Re: Permit Modification Request for the Janikowski Recycle Facility (201-2011, 1RF-510)
vv. 04/04/2024

Pilot Water Solutions (331374) would like to submit a permit modification request for the Pilot Janikowski (1RF-510). Due to a proposed pipeline route, placement of the four recycle containments needs to be changed from the original design. Pilot Water Solutions is requesting this permit modification to stay in compliance with the originally issued Janikowski Permit. Pilot would also like to reduce the size of the AST's from 60K bbl. to 40K bbl.

JANIKOWSKI RECYCLE FACILITY

PILOT WATER SOLUTIONS

SITE PLAN
JANIKOWSKI RECYCLE
PILOT WATER SOLUTION
SECTION 12, TOWNSHIP 20 SOUTH, RANGE 33 EAST
LEA COUNTY, NEW MEXICO

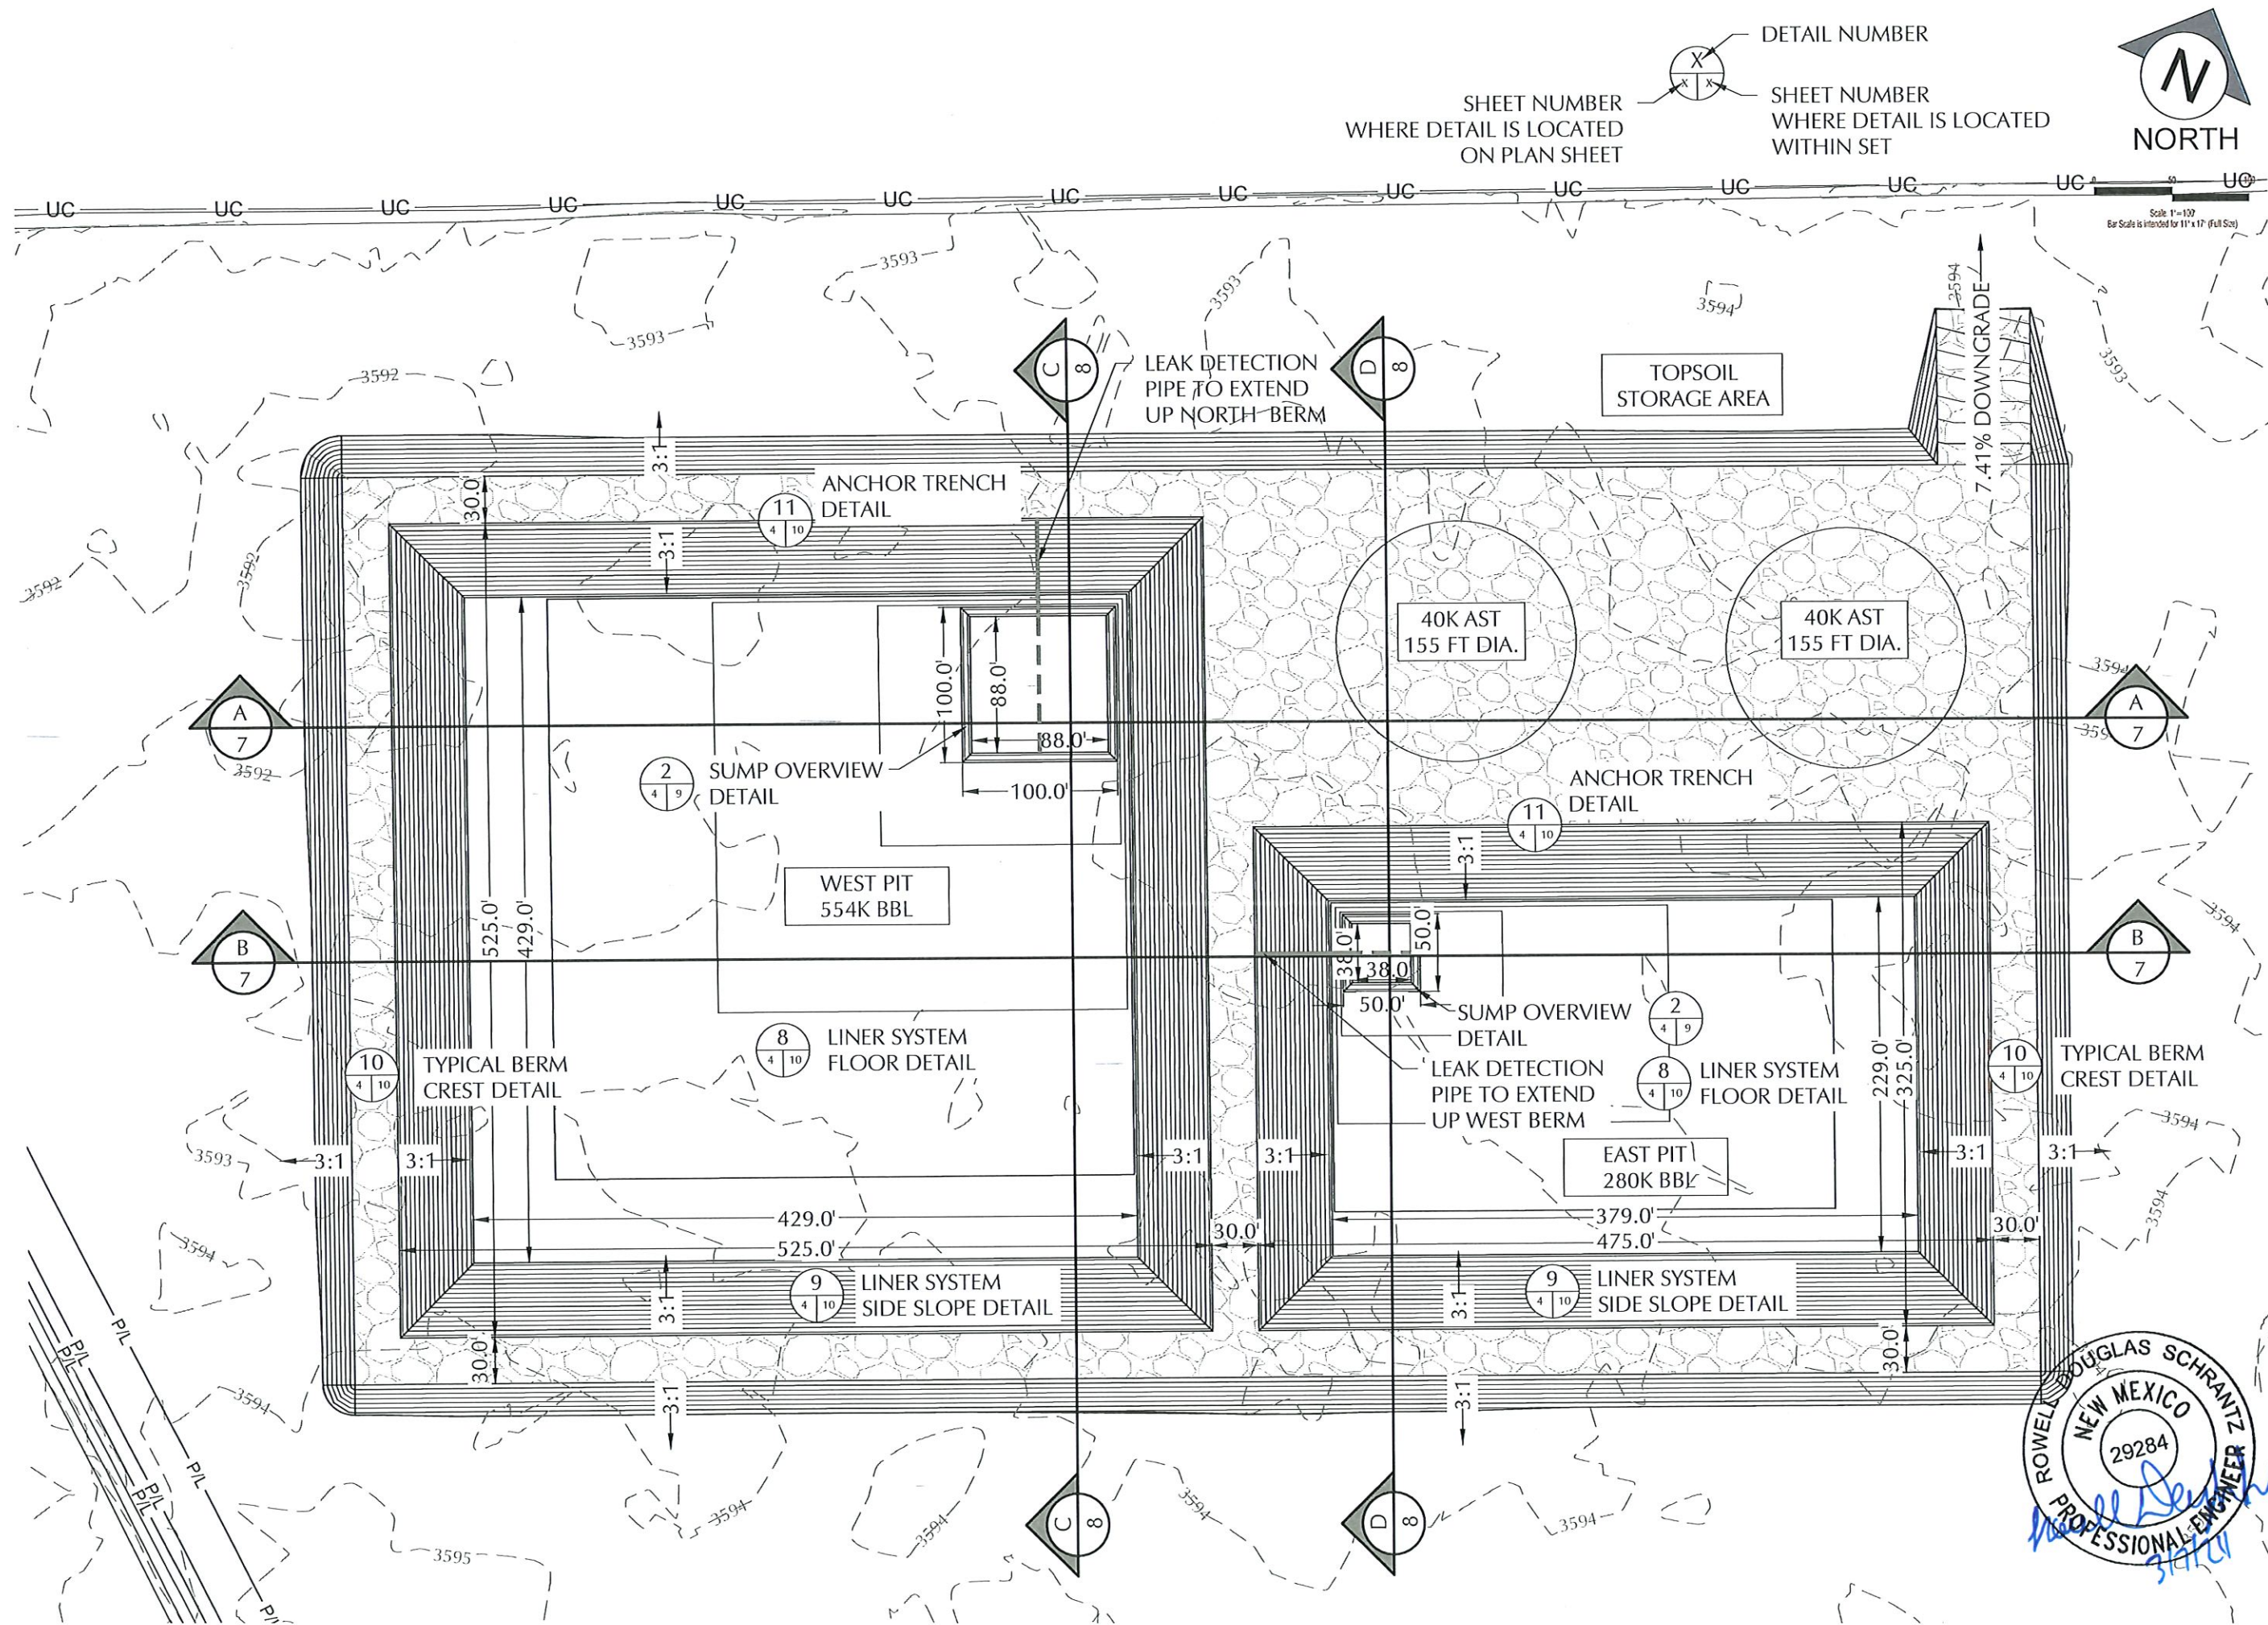
All setbacks required by NMAC 19.15.34.11 are still met. No changes to the operating plans, maintenance plans, and monitoring plans were made. Pilot intends to comply with all variances granted and all previously approved permit conditions. The only deviations from the original permit will be the placement of the recycling containments as well as the sizing of the AST's.

NMOCD has reviewed the modification request submitted by [331374] Pilot Water Solutions SWD LLC on 03/29/2024, Application ID 328025, for 1RF-510 - JANIKOWSKI RECYCLING FACILITY [fVV2331833058] in Unit Letter F, Section 12, Township 20S, Range 33E, Lea County, New Mexico. The modification request has been approved with the following conditions of approval:

- [331374] Pilot Water Solutions SWD LLC will operate 1RF-510 - JANIKOWSKI RECYCLING FACILITY [fVV2331833058] as originally permitted.
- [331374] Pilot Water Solutions SWD LLC will comply with all conditions previously approved for the 1RF-510 - JANIKOWSKI RECYCLING FACILITY [fVV2331833058] permit.
- No changes to the operations procedures, maintenance, monitoring procedures, or closure procedures will be made aside from the requested modification.
